ADDENDUM No. 3

July 23, 2019

Grant County Airport Terminal Renovation
 Grant County IFB No. B-20-02
 AIP Project No. 3-35-0039-021-2019
 NMDOT – Aviation Division Grant No. SVC-19-03

ASA Architects
 201 North Alameda
 Las Cruces, New Mexico 88005

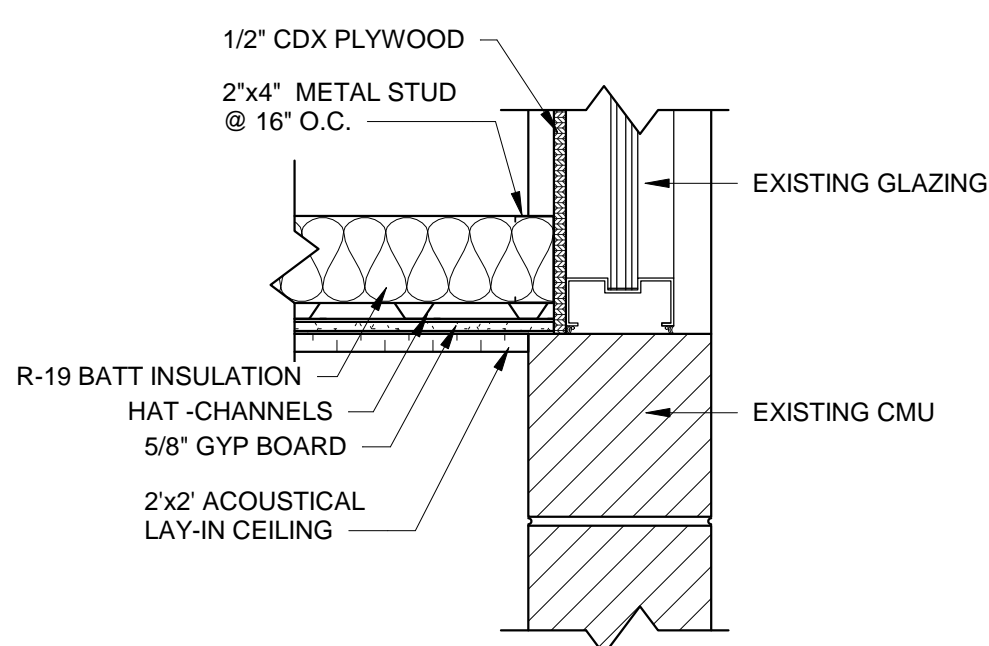
a. **ADD** sign adjacent to door 6A:

- b. **ADD** sign adjacent to door 7A:

- c. **ADD** sign adjacent to door 8A:
